# Mira Loma Road Extension Hydraulic Analysis

## Steamboat Creek

City of Reno, Washoe County, Nevada

January 1991  
Nimbus Job # 9006

Figure 3  
Bridge Cross Section

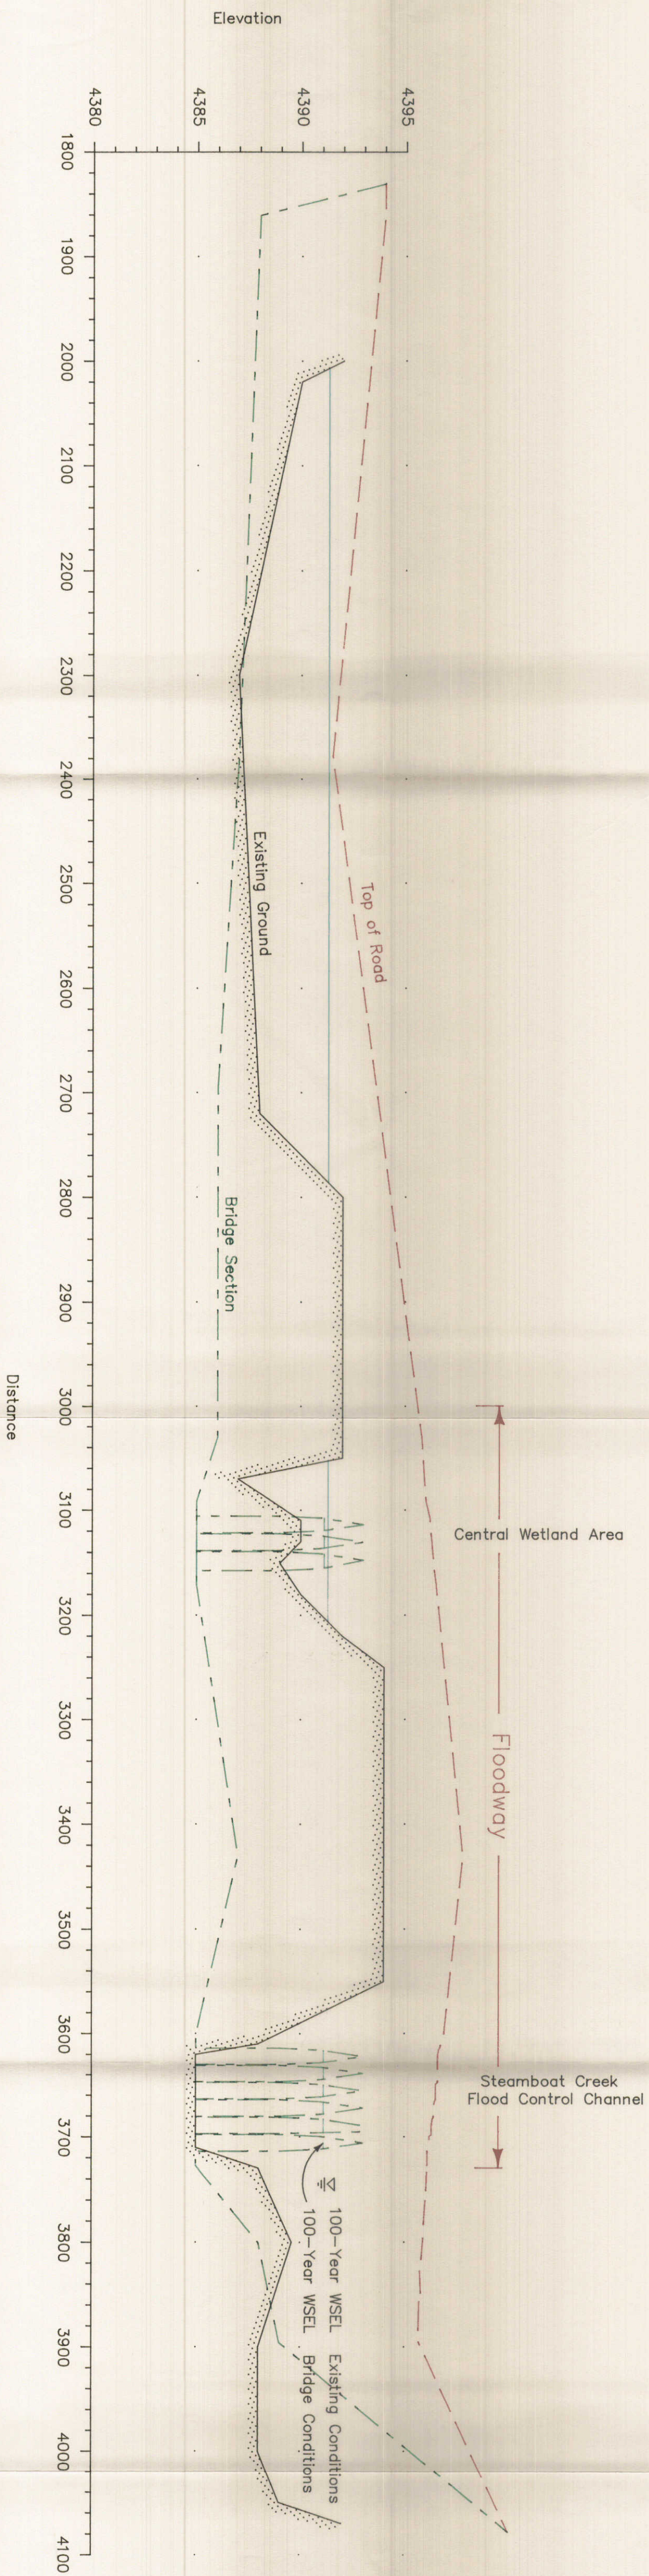
Were enough sections taken to determine that a run-out apron was not required? If the select fill may be carried from the site by the higher flow velocities, 1 check scour analysis

fill may be carried from the site by the higher flow velocities
